NOTICE UNDER SECTION 96 (1) CHAPTER IX OF THE BOMBAY
DISTRICT MUNICIPAL ACT III OF 1901 AS MODIFIED
UPTO THE 1ST MARCH 1915.Karachi, 10th may 1933..

Ground floor existing & proposed first floor.It is intended for the purpose of Residence

With reference to your application dated...10-5-33....193
with a plan for the proposed building/additions and alterations on plot
No.....117...., Survey Sheet No. J.M. 1, Janshed.....Quarter
I have to request you to comply with the following requirements:—

PLAN OF PROPOSED ADDITIONS ON PLOT 117
SHEET 3 M1, JAMSHED QUARTER.
SCALE 8'-1"

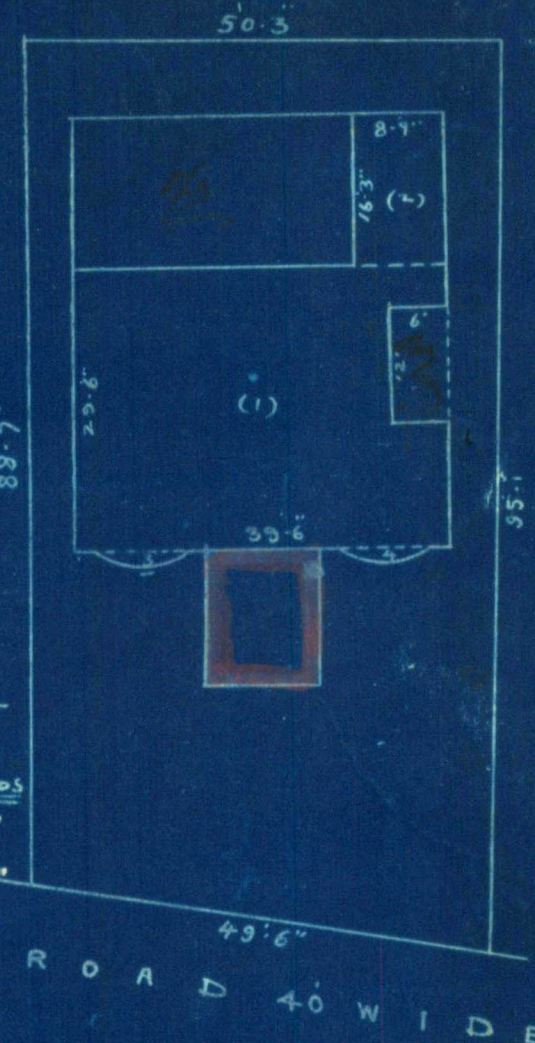
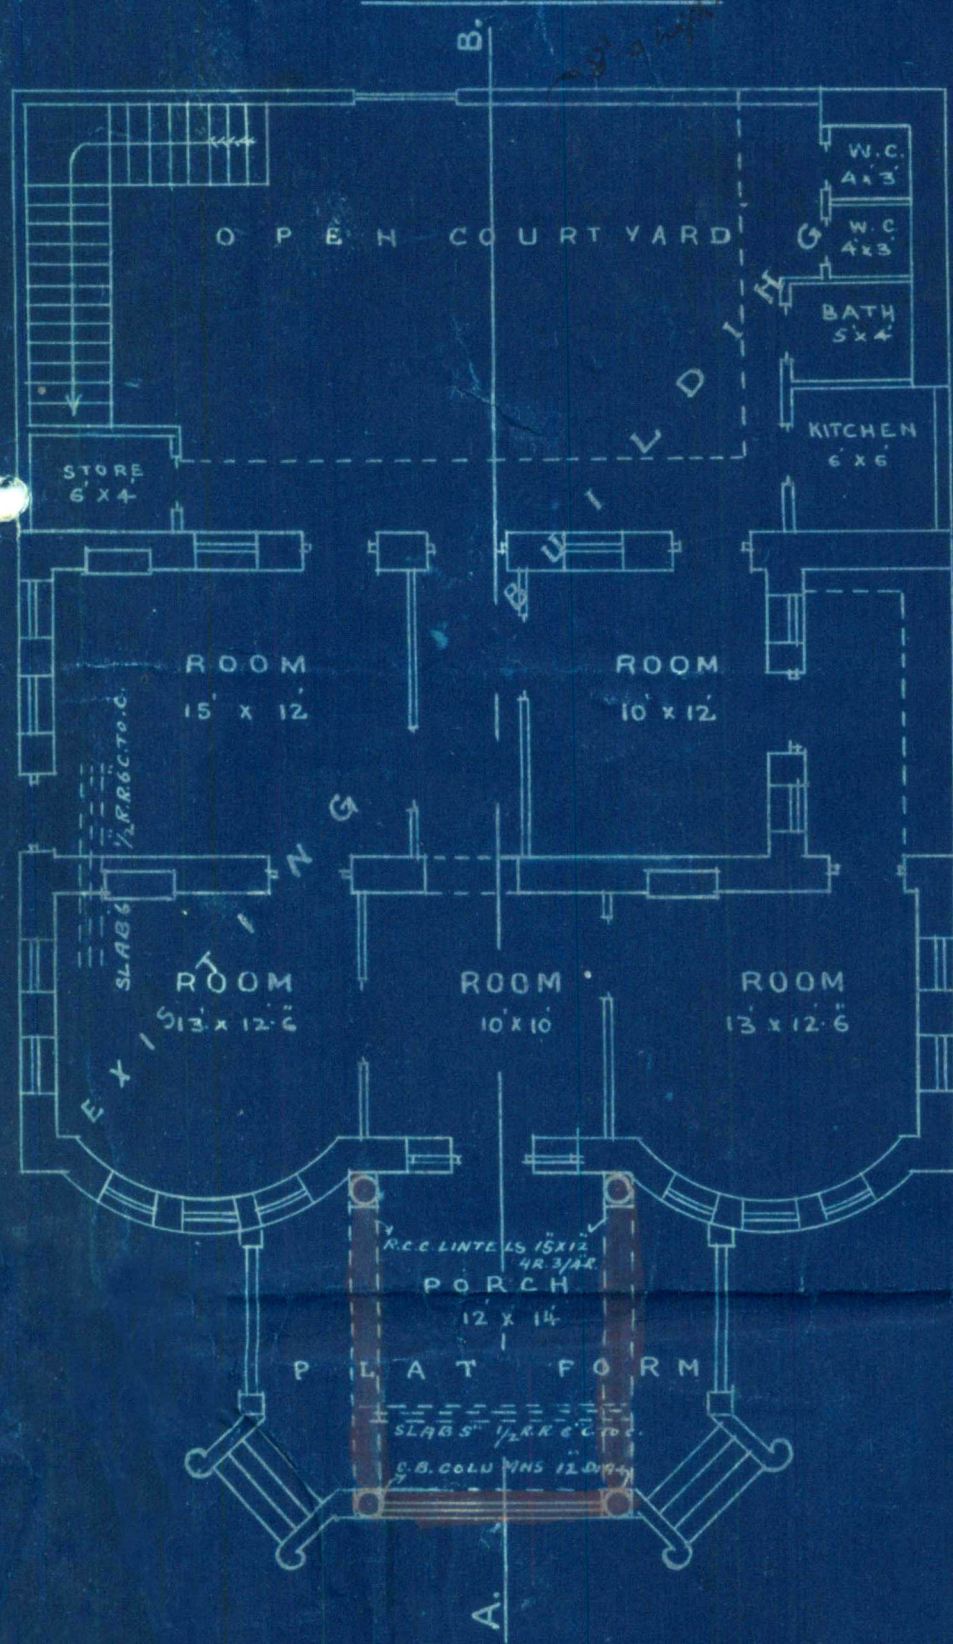
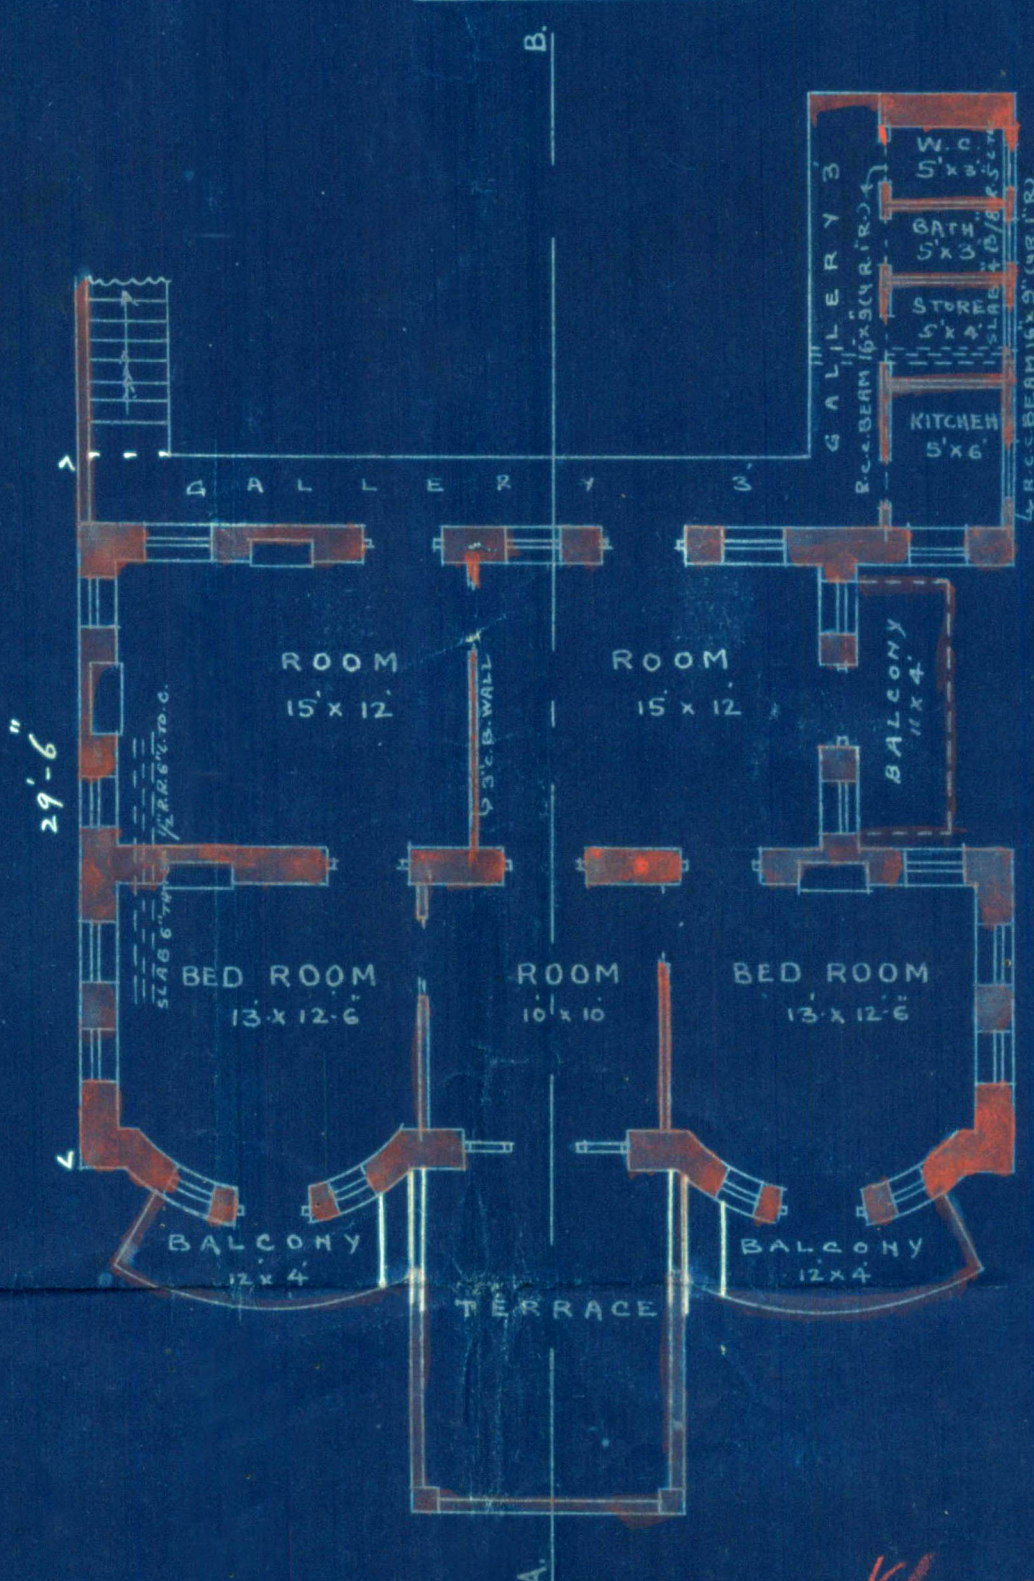
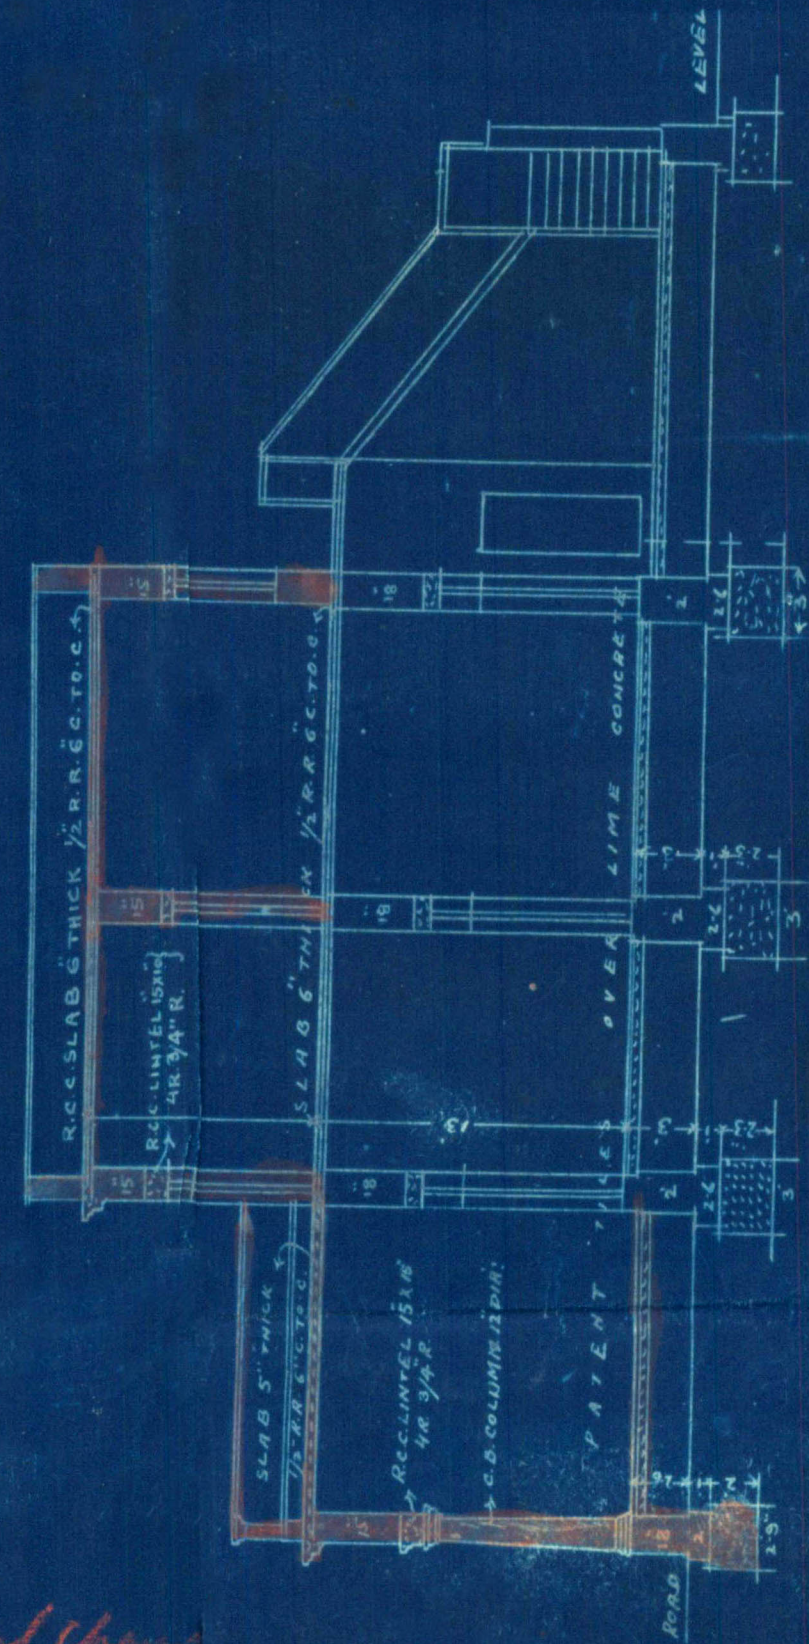
1. Continuous gallery at the rear and staircase landing must be taken as built up area, Dimensions are incorrect.
2. Front porch must also be taken as built up area.
3. Front balconies must be disconnected from the terrace otherwise they must be taken as built up area.
4. Foundations will have to be exposed and intimation sent to this office for the purpose of examination.
5. Covered porches must be considered as built up area.

1. The back Continuous Gallery
is already calculated in built-up area.
 2. Porch open on 3 sides should
not in fact be counted as built-up area
but I am showing the same as built-
up area in protest.
 3. Front balconies have been
disconnected from terrace.
 4. Foundation have been exposed
for your examination.
- We shall thank you to pass
the plans early
